PLANNING COMMISSION MEETING AGENDA

DECEMBER 3, 2024

a. SOHO Development Approving a large-scale development at 4900, 4901, 4902, 4903 & 4907 W. Pleasant Drive for 63,818-sf of building space on 239,955-sf of site area in the T5.2 (City Medium-Intensity) zoning district, formerly zoned C-3 (Neighborhood Commercial).

EROSION CONTROL PLAN
STAGE 2

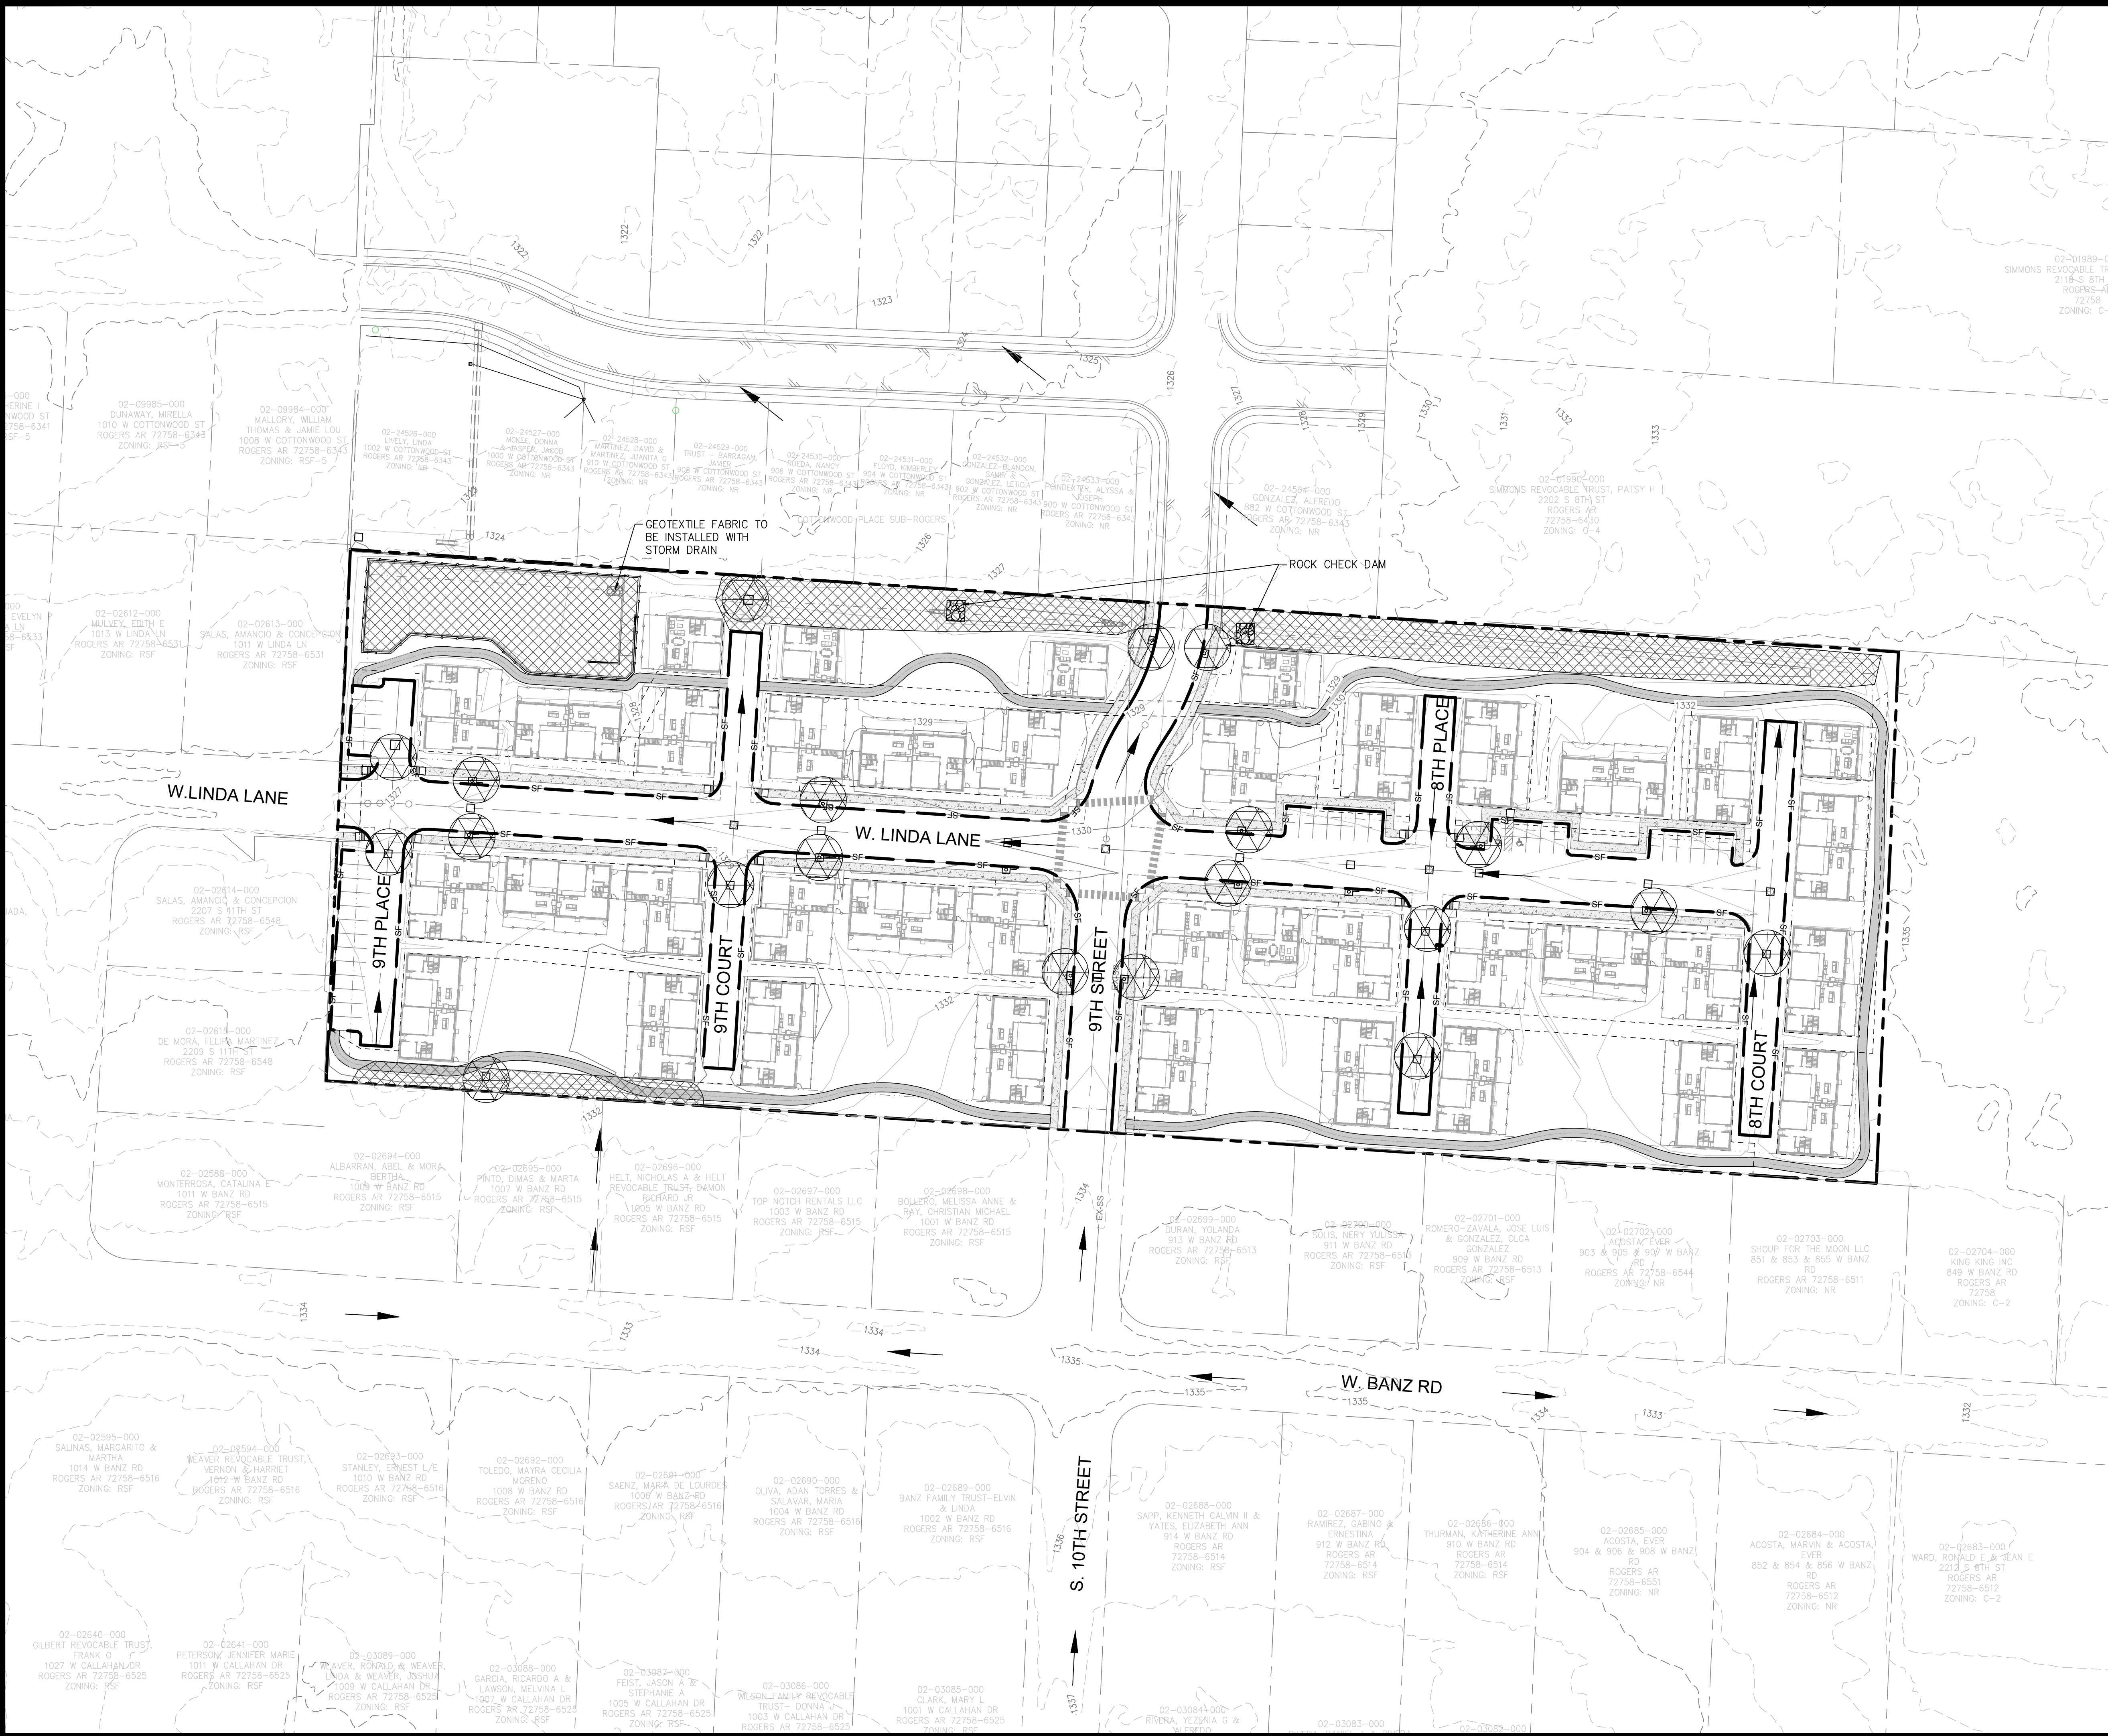
This submittal doesn't include landscaping plans or tree preservation plans. Resubmittal required, with the inclusion of those pages that match that of the last submittal.

Sewer must be extended to the east property line, such that both properties may be served. (See the note on sheet 18.)

Show all inverts into manholes. Match pipe crowns when pipe diameter changes. (i.e. 4" service pipe crowns must match the pipe crown of the out-flowing 8" pipe)

The utility easement boundary lines must be located a minimum distance of 7-1/2 feet or the depth of the main, whichever is greater, from the water or sewer line. (See previous comment RWU-66)

General Comment: Minimum 3' bury for water mains.

Pine Street Townhomes Plan Set.PDF.PDF Markup Summary

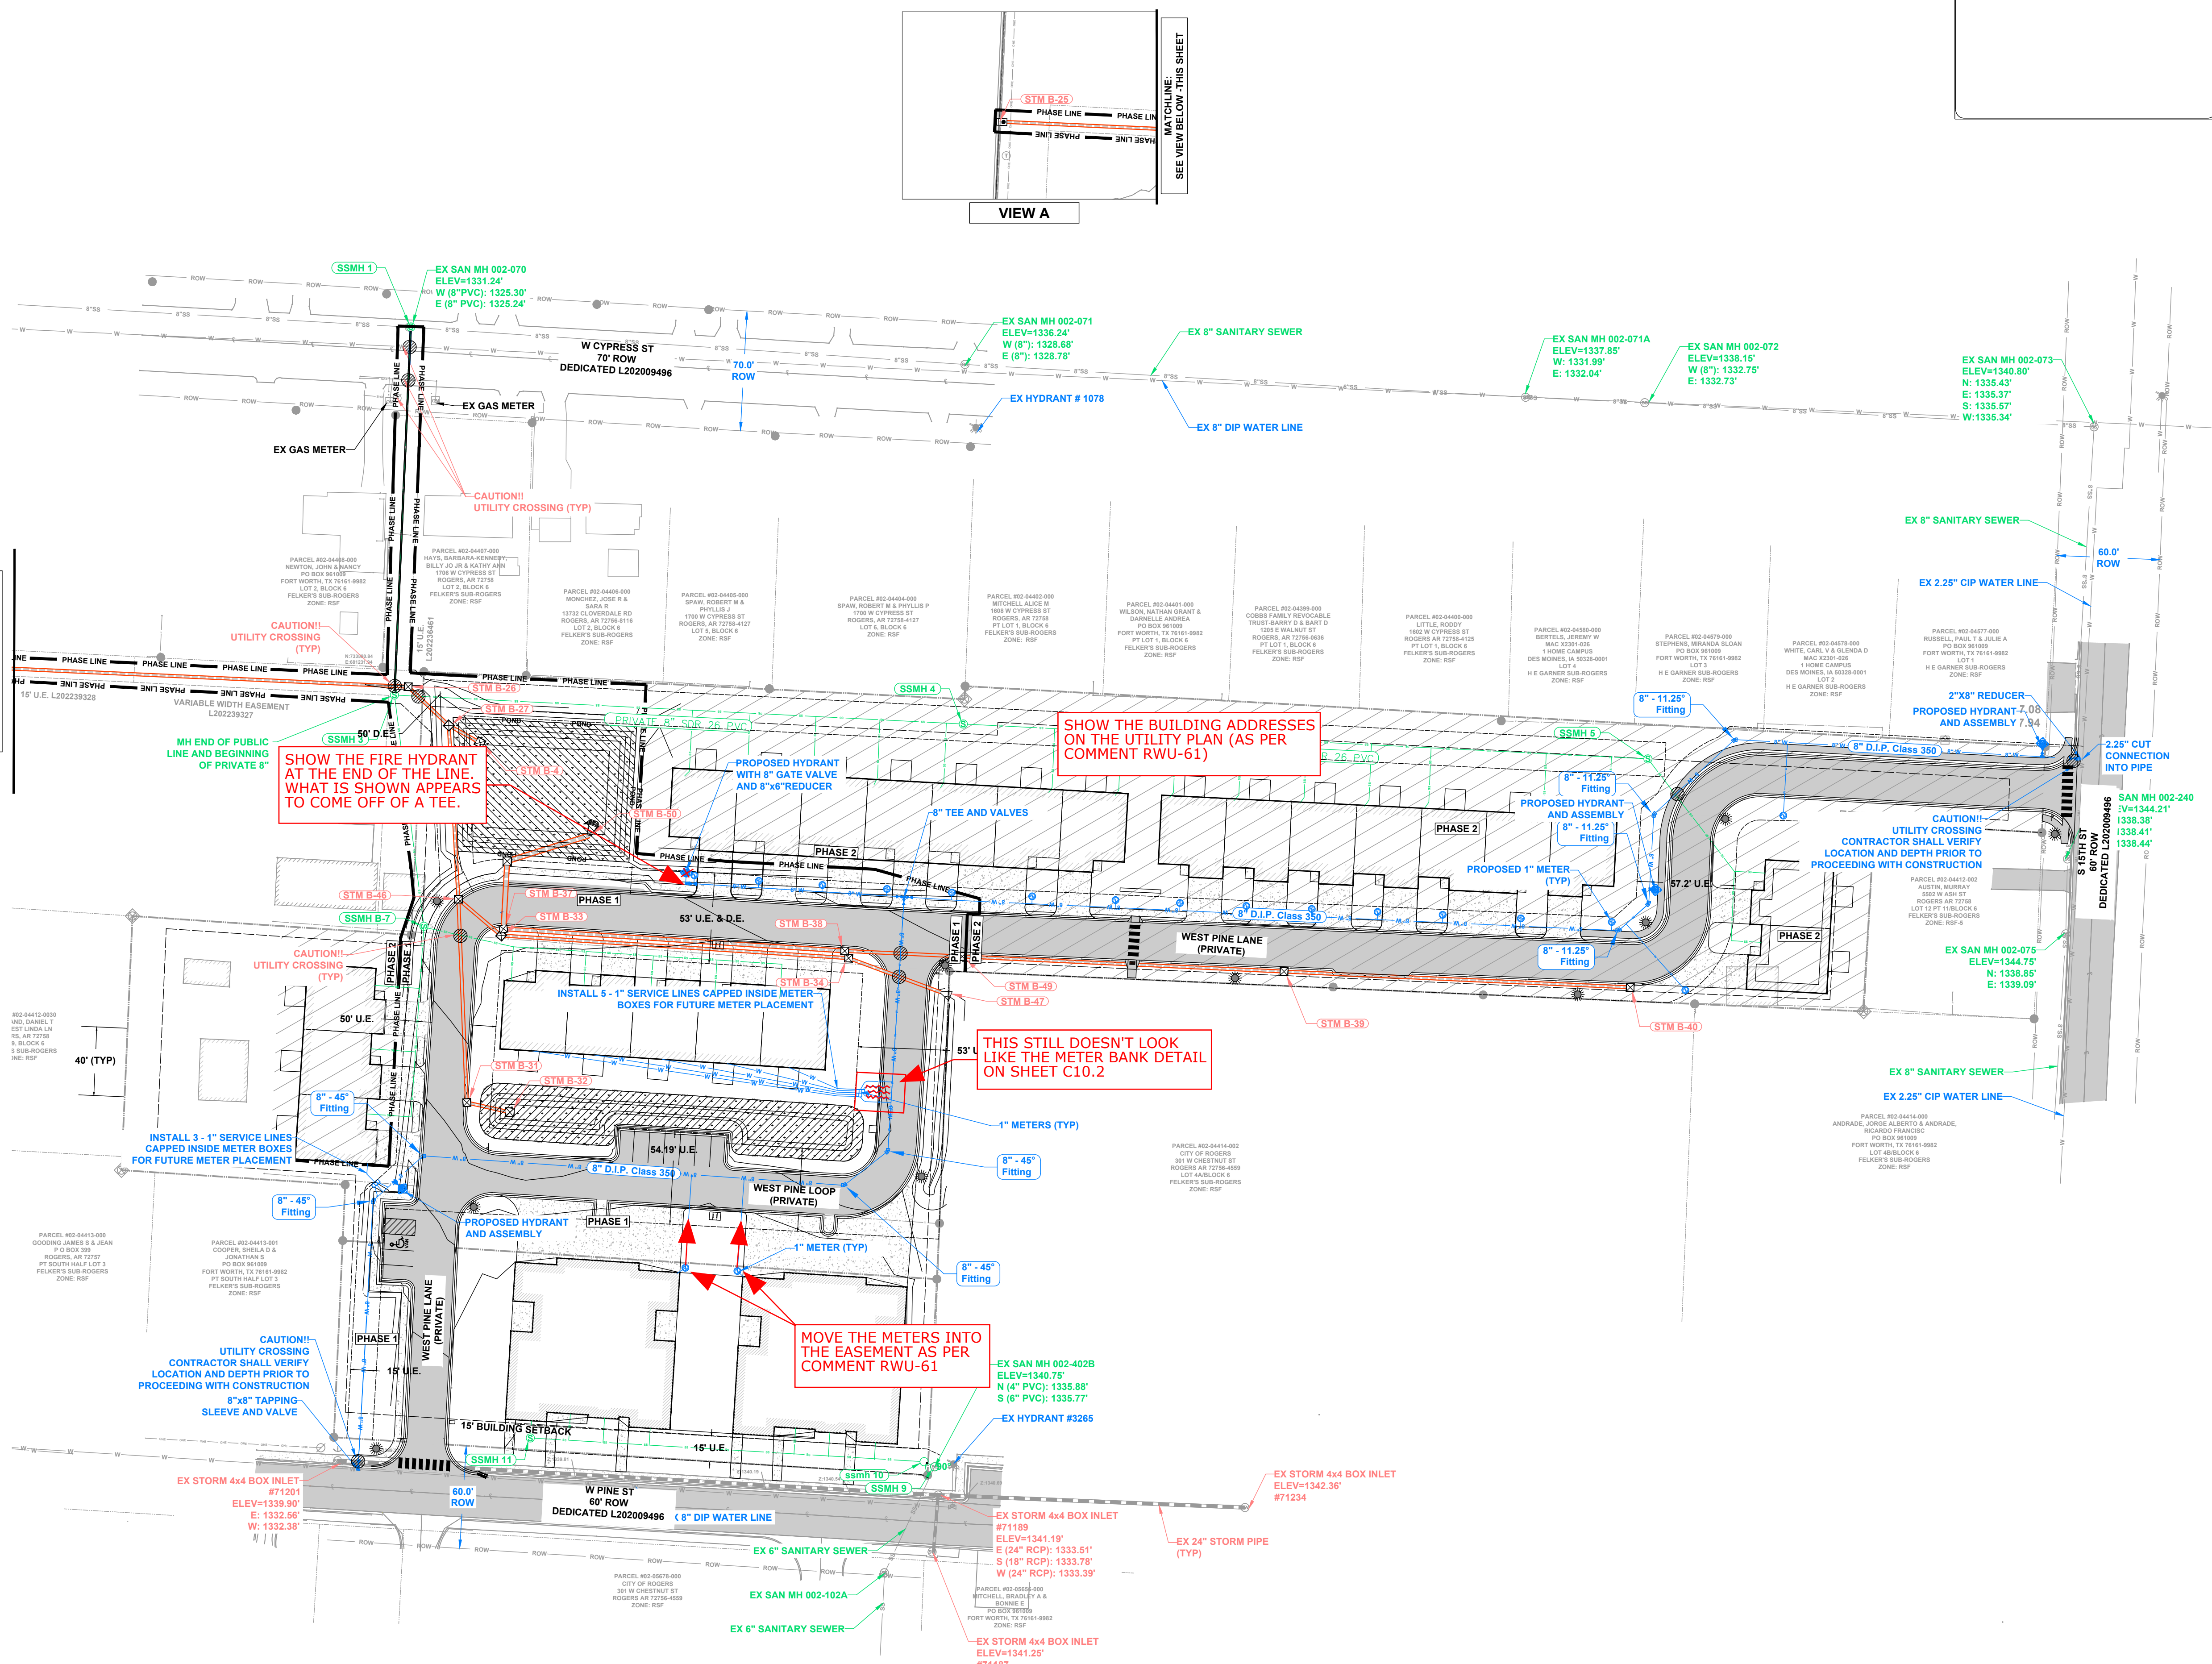
Since the water main won't be extended to the west, place an 8" gate valve, 8"x 6" reducer, and fire hydrant at the end of the main. (Verify this change is reflected on both the plan and profile views.) The way it is currently shown appears as though the fire hydrant is attached to a tee. (See all mark-ups on SHEET 13)

Show the building addresses on the Utility Plan. The meter bank shown on the plan doesn't look like the Meter Bank detail. There are some meters that are shown outside of the utility easement. (See all mark-ups on SHEET 13)

There is a sanitary sewer main crossing and a large sewer service line crossing missing from the storm sewer profiles. (See the mark-ups on SHEET 14)
